Accessibility Evaluation

Monroe County Polling Location

Burgoon Baptist Church
8598 E Burgoon Church Rd
Bloomington, IN 47401

Report Date: 04/07/2026

Finding: 3

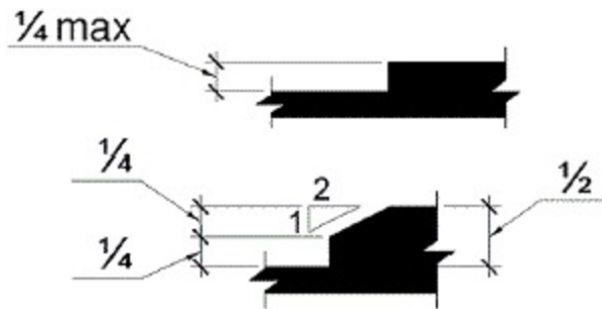
The threshold is greater than 1/2 inch high.

The threshold at a doorway shall be no higher than 1/2 inch. Changes in level between 1/4 inch and 1/2 inch must be beveled at 1:2 or less. 1/4 inch is the maximum vertical rise.

2010 ADAS Section 404.2.5

Thresholds, if provided at doorways, shall be 1/2 inch (13 mm) high maximum. Raised thresholds and changes in level at doorways shall comply with 302 and 303.

Recommend adding a temporary or permanent threshold reducer.

Finding: 4

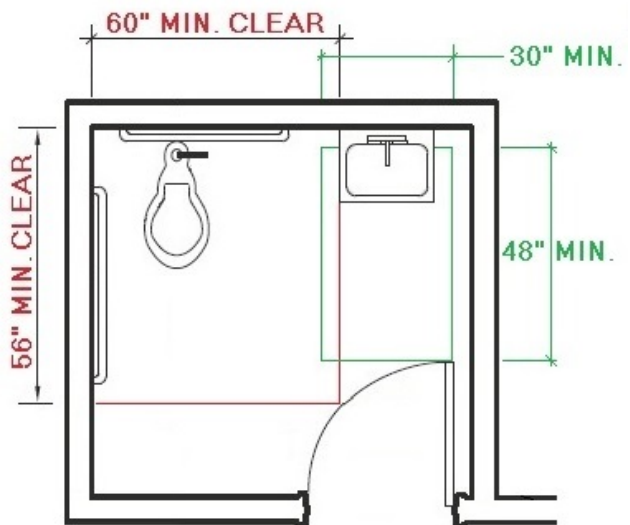
The restroom is not compliant. It may have some or all of the following problems:

The restroom does not have the required minimum clear floor space or maneuvering clearances for the toilet. The restroom does not have the required minimum clear floor space or maneuvering clearances for the lavatory. The entry door does not contain the required minimum maneuvering spaces on the pull/push sides. The entry door encroaches into the required clear floor space for fixtures. Grab bars are missing and/or incorrectly installed. Accessories, such as toilet seat covers, paper towel holders, garbage cans, hand dryers, and mirrors are either too high or without clear floor space or both.

2010 ADAS Section 213.2

Where toilet rooms are provided, each toilet room shall comply with 603. Where bathing rooms are provided, each bathing room shall comply with 603.

Recommend adding signage indicating that there are no accessible restrooms and directing voters with disabilities to the front of the line. Alternatively, add an accessible portable toilet in the parking lot.
